## REMARKS

The Examiner's Office Action of 07/07/2005 has been reviewed.

FIG 1

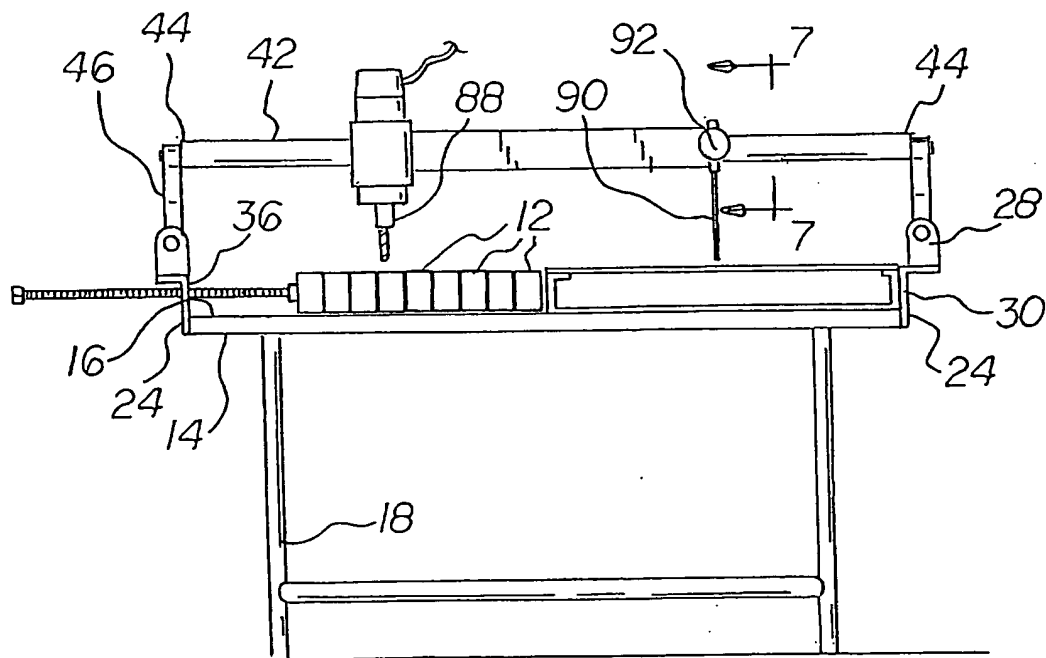
In further response to the objection to the drawings regarding reference signs not included in the description, reference character "40" has been added to Figure 1 and "62" has been added to Figure 5. The Examiner's attention is directed to Figure 5 wherein reference character "54" appears in the drawings as originally submitted.
